Public comment response

January 2, 2026

Re: Project File #608020 Cape Cod Bridges Project

Figure 2 - Location of proposed overpass versus existing path plan

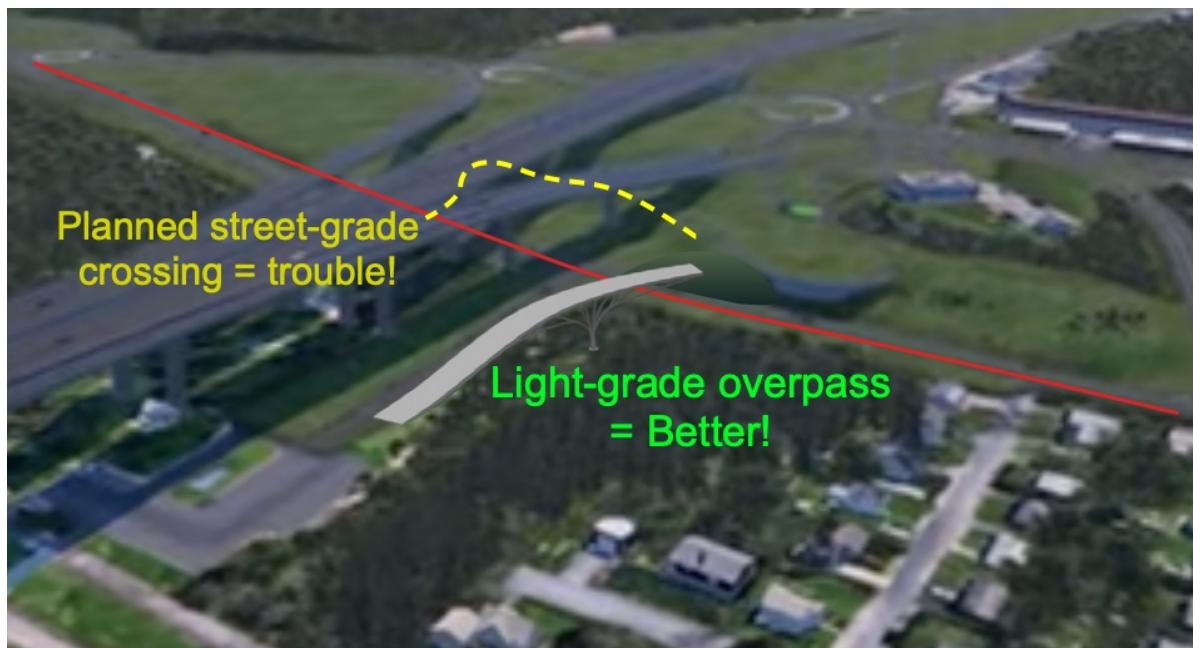
A light, ramped, grade-separated bike & walker overpass is a simple cost-effective solution that **eliminates the problems entirely**. An overpass can leverage existing site elevation and the already-planned retaining wall to descend towards the canal into the Bourne Recreational Area. Figure 2 illustrates this.²

This overpass constitutes a reasonable design alternative that meets the project's purpose and need while reducing adverse effects on both the human and natural environment. The benefits are clear:

Figure 3 - Descent grade eliminated

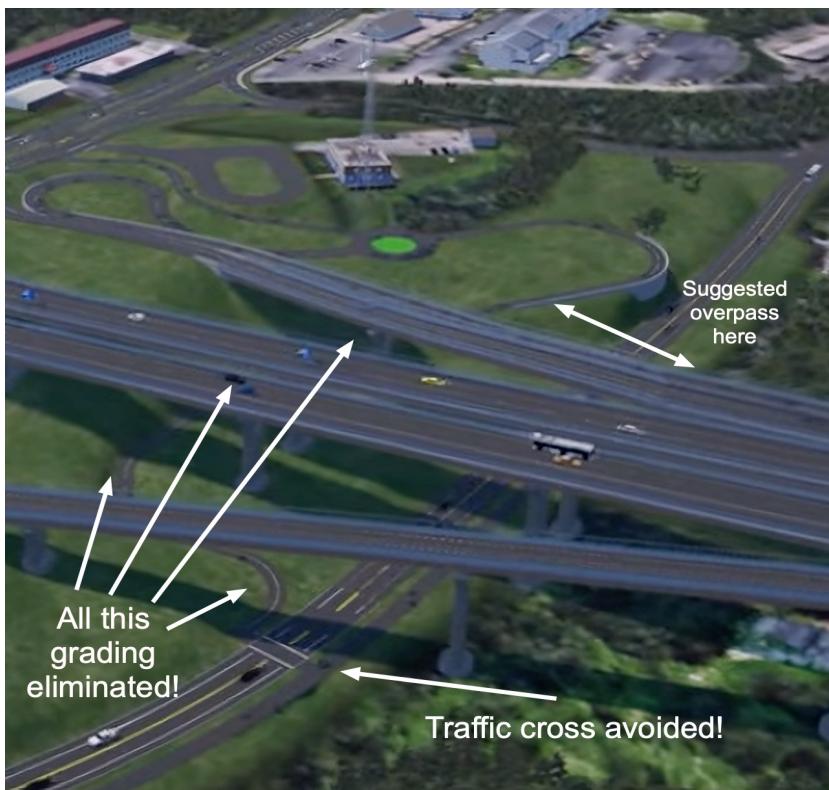
- **The change leverages planned structures.** A structural berm and major path descent are already included in the current plan; these elements can be reworked to form the southerly approach to the overpass. The northerly descent can be accommodated by a light, non-vehicular structure. Note: A U-shaped ramp might be required due to the elevation descent required.

- **No new property required.** The northern side of the overpass, which constitutes the descent over grade, can descend into the existing Bourne Recreation Area and Cape Cod Canal District property. No property taking is required. See rough placement illustrated in Figures 3 & 4.
